ADDENDUM NO. 1 TO BID NO. 13-0107-4

FOR: CLOVERDALE COMMUNITY CENTER

PLEASE SEE THE FOLLOWING FOR ADDITIONS, CLARIFICATIONS AND/OR CHANGES:

A-2

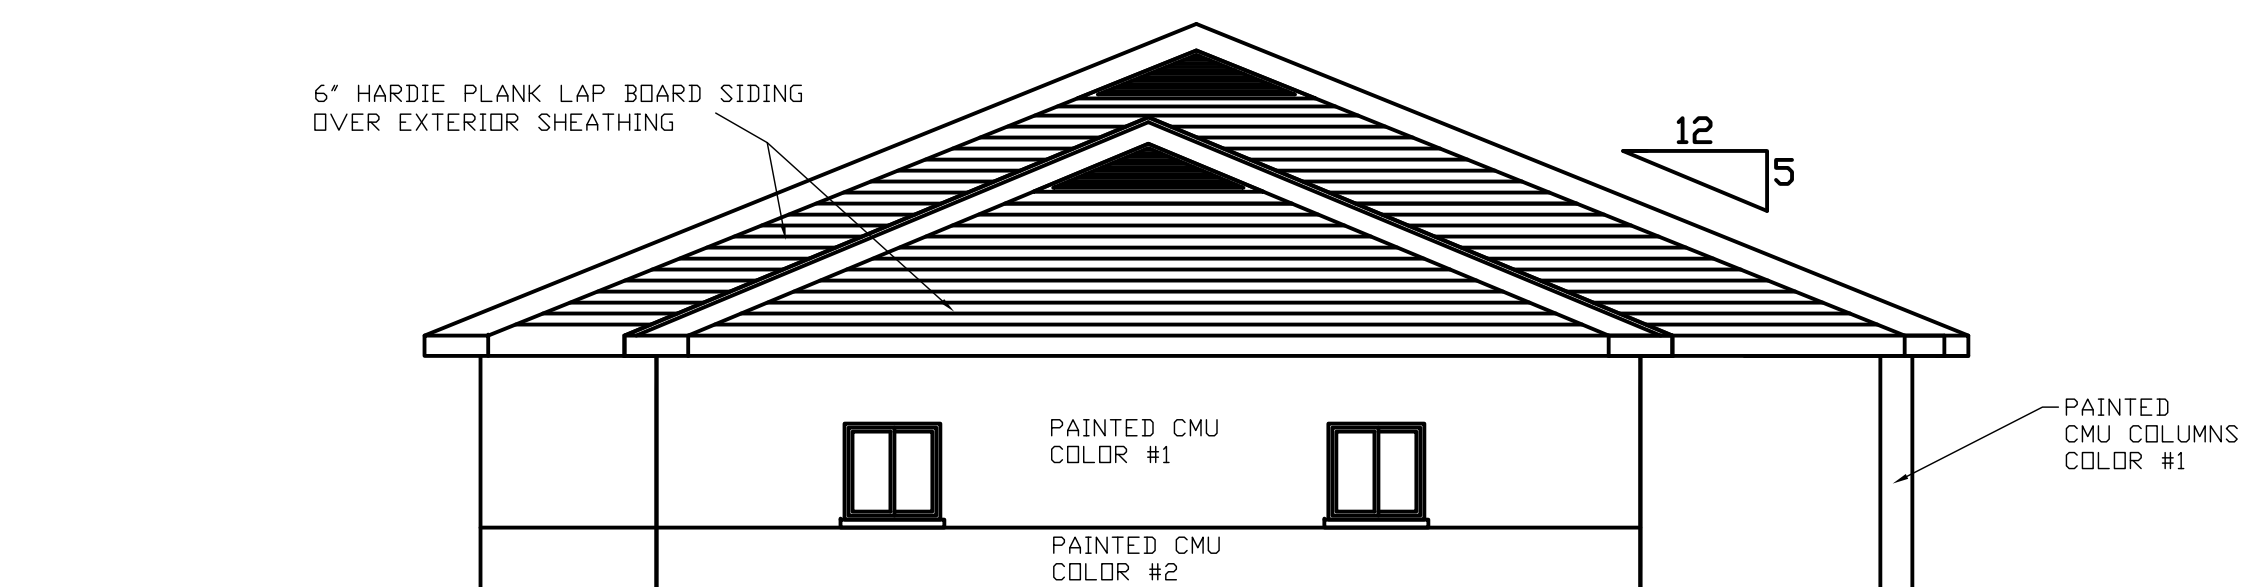
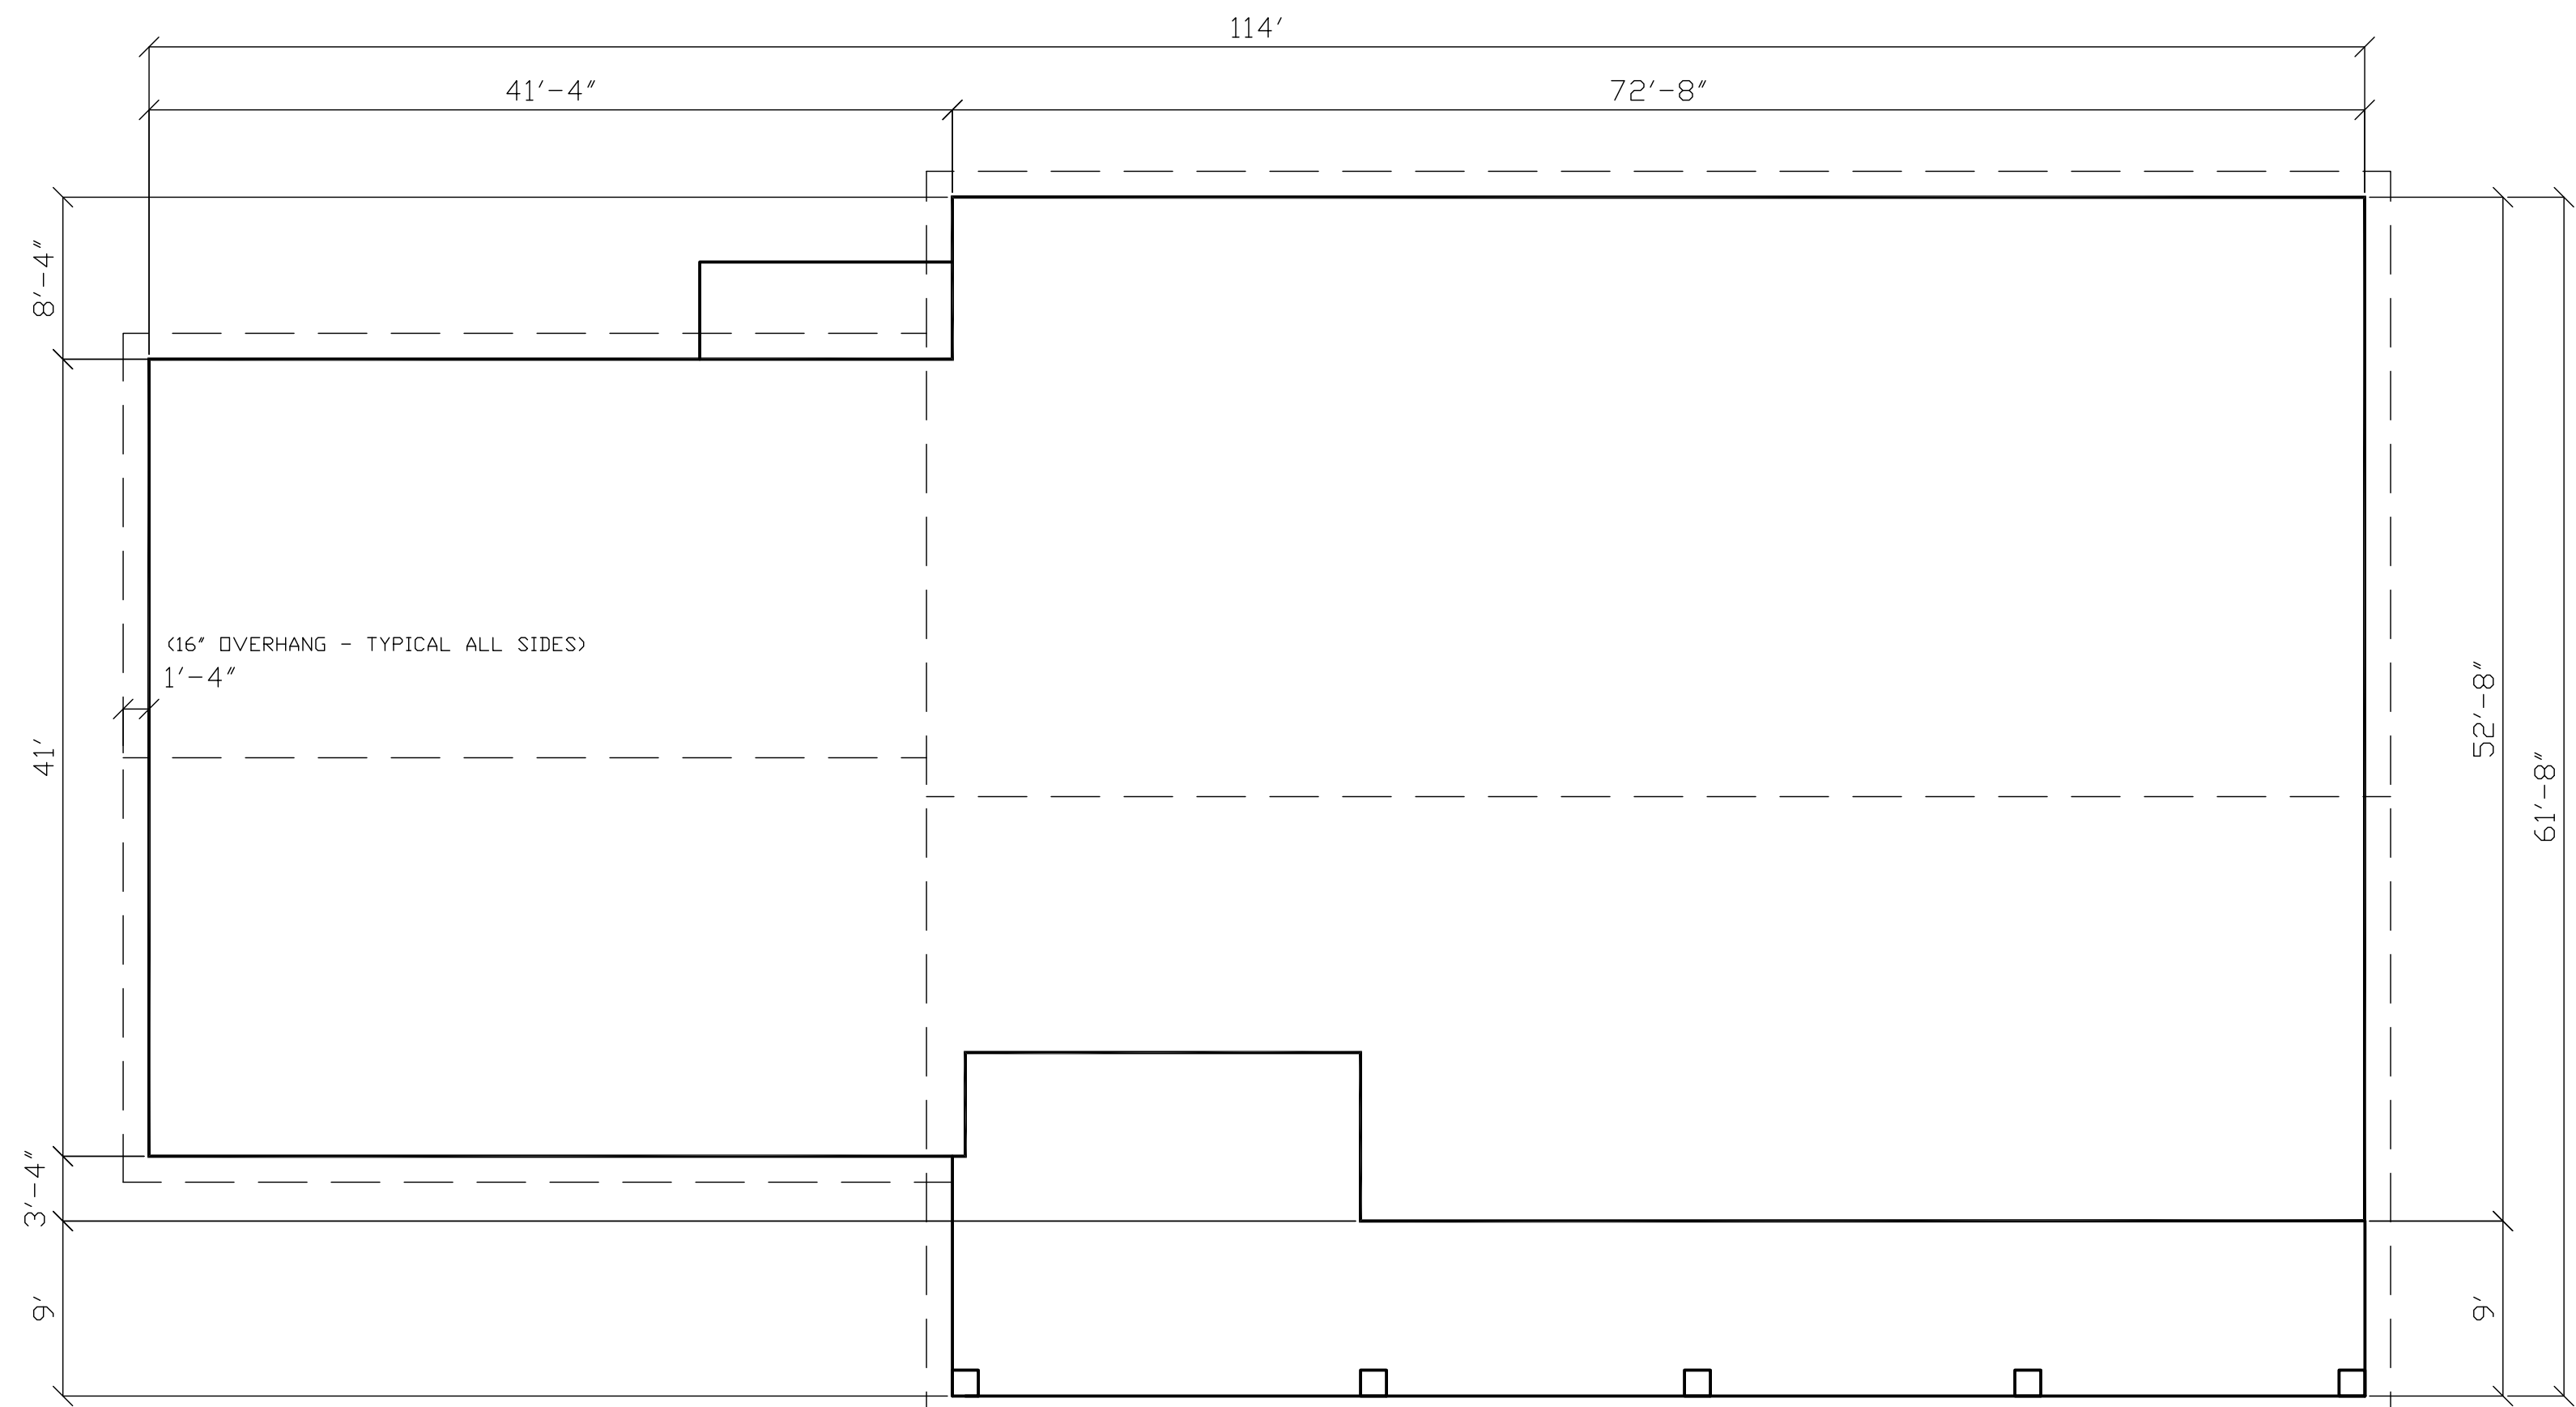
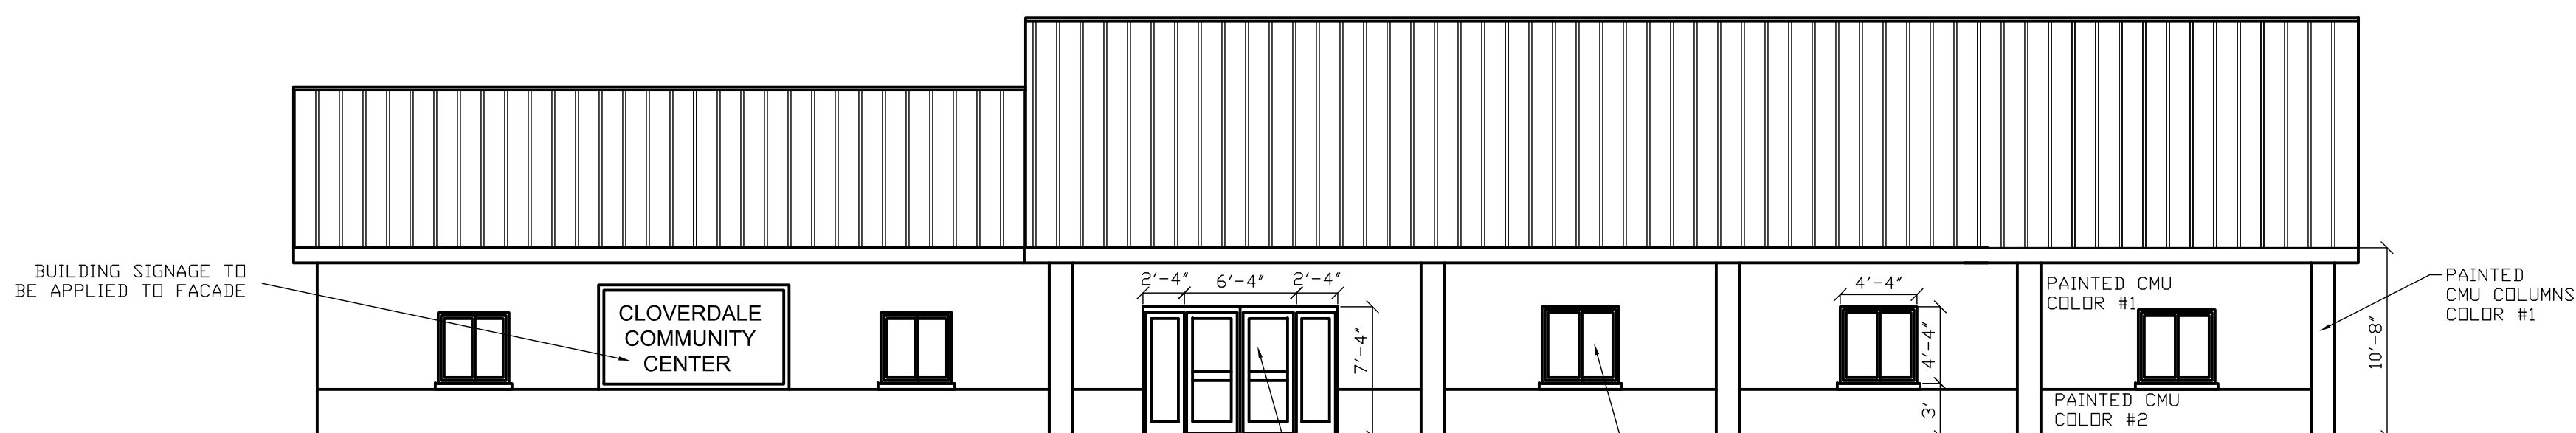
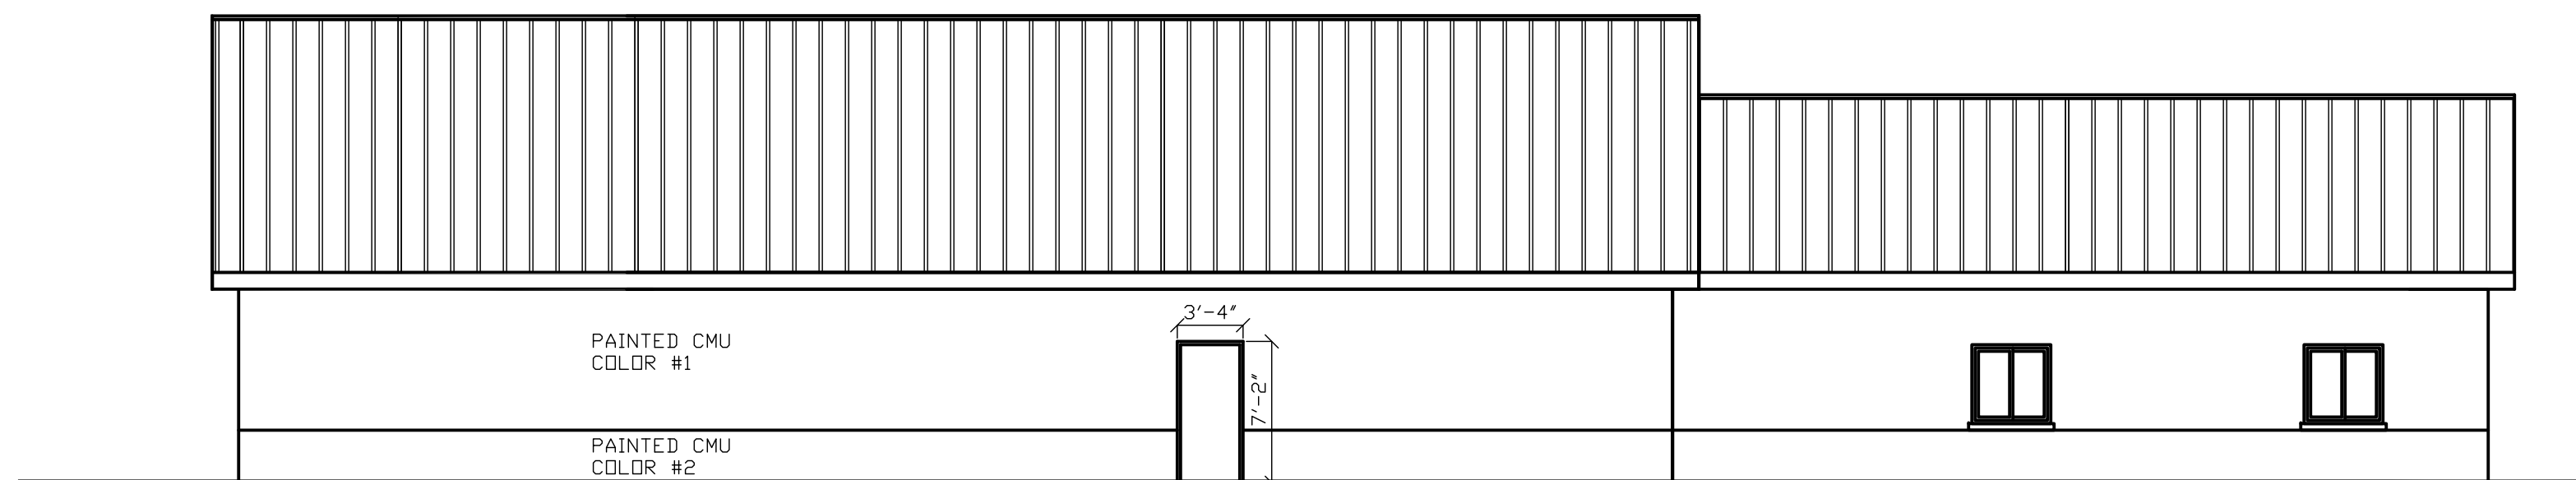
2. Q) Drawings show sliding windows, specs call for non-impact in-swinging awning type with rates glass. Please clarify.

A) *See revised sheet A-2, date 11-22-13. Windows shall be pre-finished aluminum windows, horizontal slider with insect screens, lock, low-E, impact glazing.*
